Figure Z-24A. Adding OV Protection and Pilot Control to an Internally Regulated Alternator

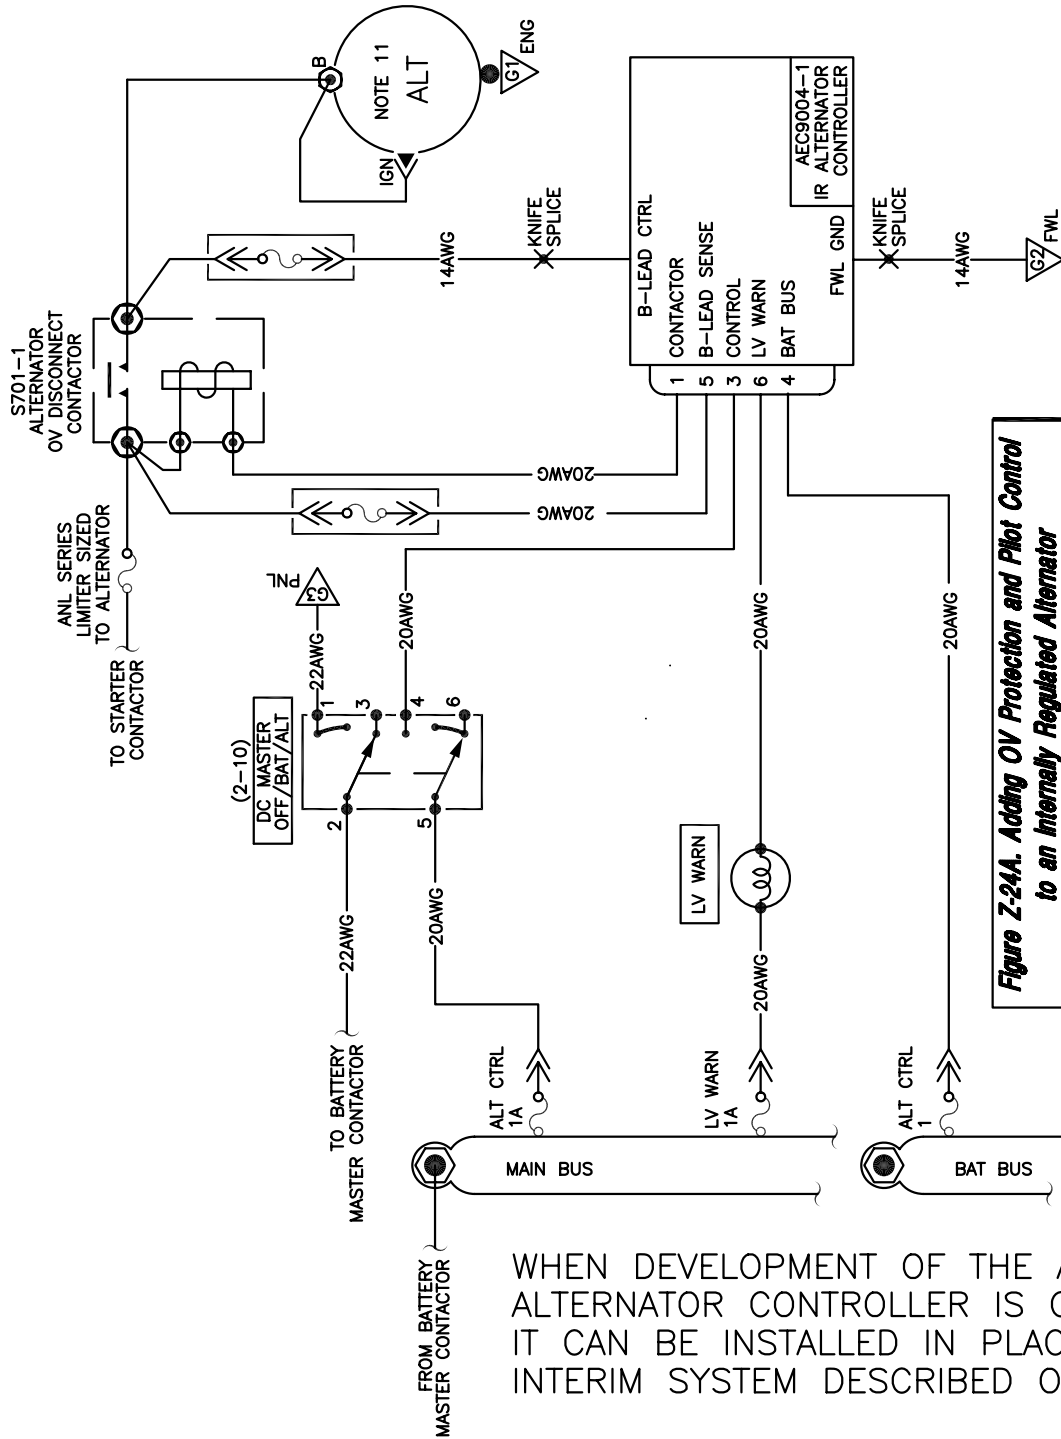
WHEN DEVELOPMENT OF THE AEC9004 ALTERNATOR CONTROLLER IS COMPLETE, IT CAN BE INSTALLED IN PLACE OF THE INTERIM SYSTEM DESCRIBED ON PAGE 1.0

THE SAME DISCONNECT RELAY AND CONTROL SWITCH ARE USED. THE OVM-14 MODULE IS DISCARDED. THE AEC9005 CONTROL MODULE ADDED AND A L.V. WARNING LIGHT IS ADDED.
